One University Place Construction Update 2  
11/12/15

RE: One University Place – Construction Changes

RE: OUP East Ravine Restoration

Figure 1: 2.5:1 Slope (Base Map and grading provided by MMS Consultants)

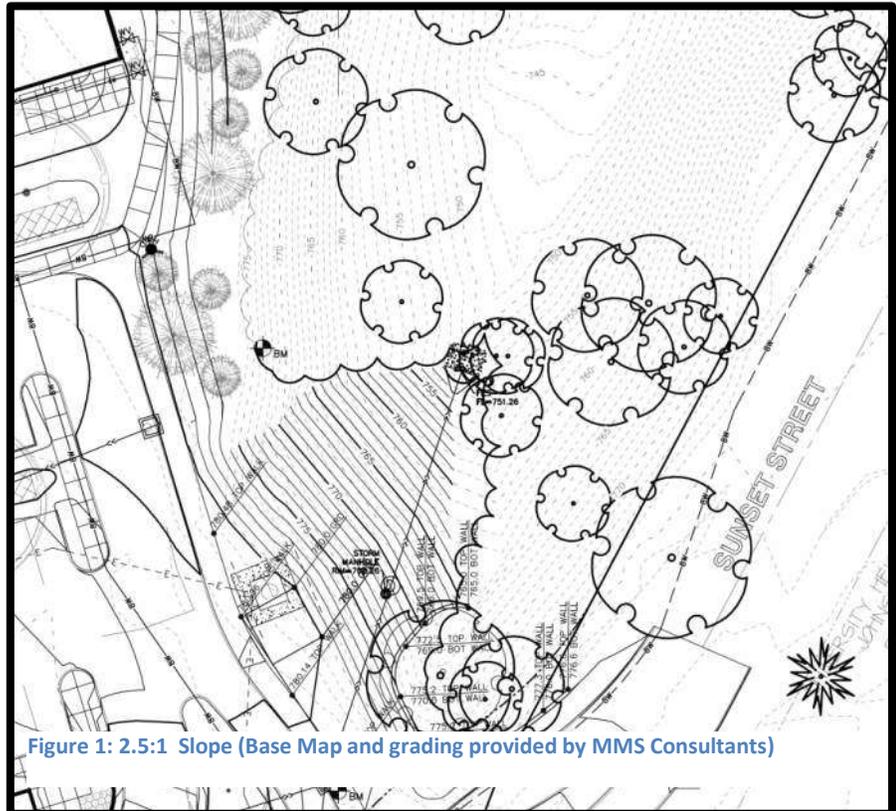
### Proposed 2.5:1 Slope:

The proposed plan shows a 2.5:1 slope with a retaining wall protecting three (3) trees in the southeast corner and no additional trees to be removed. It is worth noting that there will be some tree removal along the west slope following the remove of "junk" along the bank.

2:5:1 slopes can be difficult to stabilize, but can be done with fabric to control erosion. Establishing vegetation, especially native vegetation, can be difficult because a 2:5:1 slope is NOT considered a "mowable" slope. To establish native plants with seeding, the area needs to be mowed in order to control weeds. If the area cannot be mowed, controlling weeds will need to be done by hand. To establish a native planting from seed takes a minimum of 3 years. Long term maintenance to control weeds is needed.

In summary, this plan meets the goal of keeping trees, but the proposed slope is steep. I recommend this option ONLY if the desire to keep the trees outweighs the desire of easier short and long term management of the site.

Figure 2: 4:1 Slope (Base Map and grading provided by MMS Consultants)

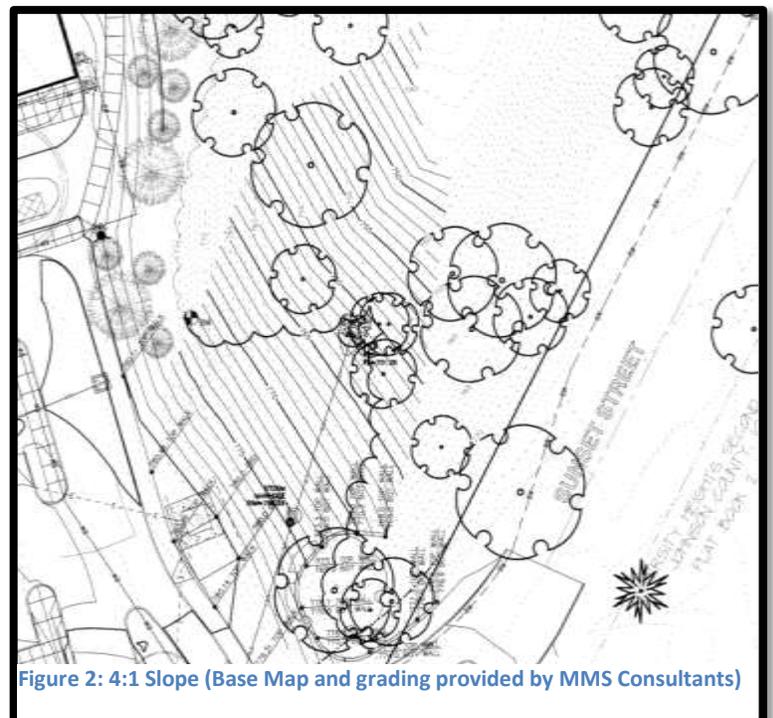
### Option 1: 4:1 Slope:

This would be the most stable of the three options. The slope could be mowed to control weeds to help with the establishment of new trees and shrubs. However, as you can see in Figure 2, a 4:1 slope will require at least six (6) medium to large trees to be removed including a large Catalpa tree with a significant canopy (Photo 4). The roots of other trees may be impacted if grading occurs within the drip line of the trees. This meets the goal of having a stable slope but does not meet the second goal of protecting trees because it removes a large tree with a large canopy.

Figure 3: 3:1 Slope (Base Map and grading provided by MMS Consultants)

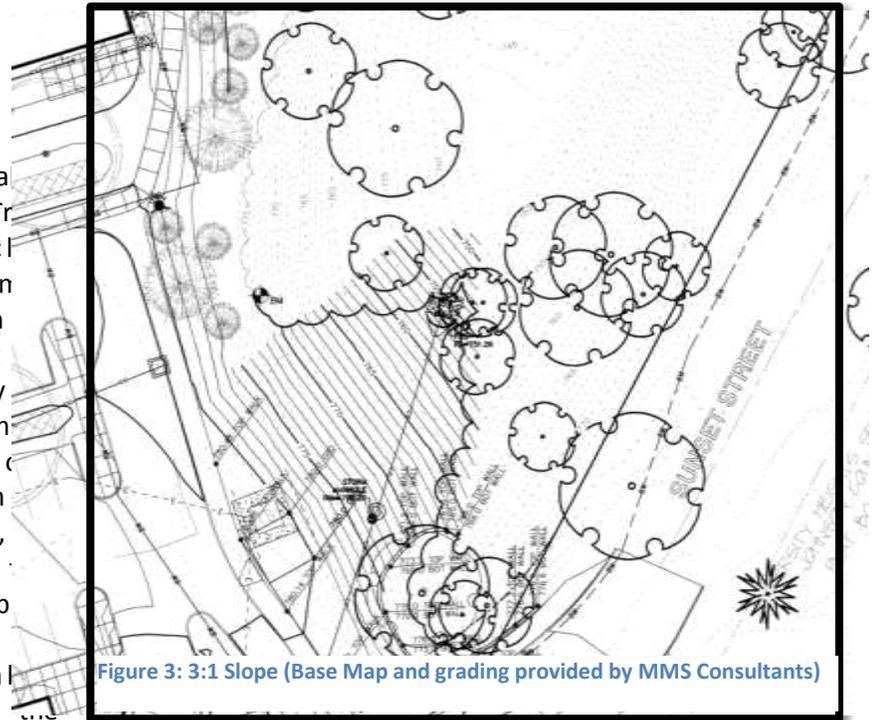
### Option 2: 3:1 Slope:

For this option, the slope would not be “mow a but would be more stable than the 2.5:1. Four Tr would need to be removed. Those trees incl ashes and smaller walnuts. The Ash trees will n likely be impacted by the Emerald Ash borer in near future and walnuts are fairly quick growing there are many other walnuts in the area. They also small enough and at a low elevation, with m other surrounding trees, so removing them w not significantly alter the canopy, as visible from road. In summary this would remove some trees, would provide a more stable slope then proposed. If this level of tree removal is acceptab recommend the site graded at a 3:1 slope. recommended at least 4” of topsoil be placed al the slope. Following seed bed preparations, this slope should be seeded with a temporary seed mix of

Winter Wheat (*Triticum aestivum*) at a rate of 10lbs per acre along with the recommended permanent seed mix (see below). Caution: No other erosion stabilization mix other than the winter wheat should be used as it will hinder the establishment of native vegetation. We recommend the use of erosion control matting following the temporary seed and permanent seed mix.
